Company	Trenz Electronic GmbH
PCN Number	PCN-20210121
Title	TE0726-03 DDR3 Change and Product Update
Subject	BOM change
Issue Date	2021-01-25

This change affects Trenz Electronic boards TE0726 of Revision 03: TE0726-03-*

2.1 #1 Change DDR3 RAM (U8) from IM4G16D3FABG-125I to IS43TR16256BL-125KBLI

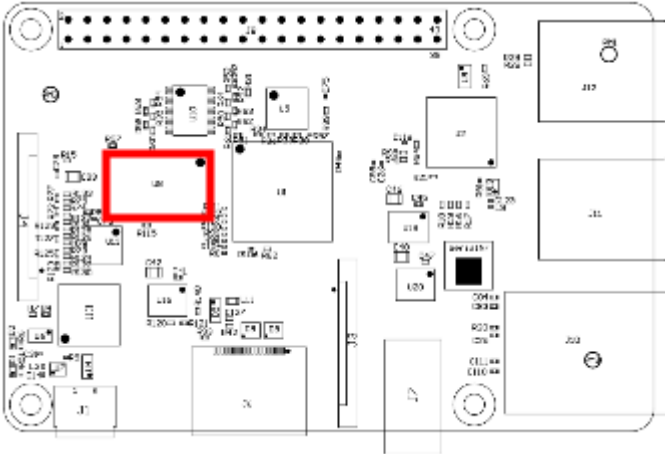
Reason: Component is end of life.

Impact: New DDR timings may be considered in designs.

Locate DDR3 RAM (U8) on top side of PCB:

old	new
IM4G16D3FABG-125I	IS43TR16256BL-125KBLI
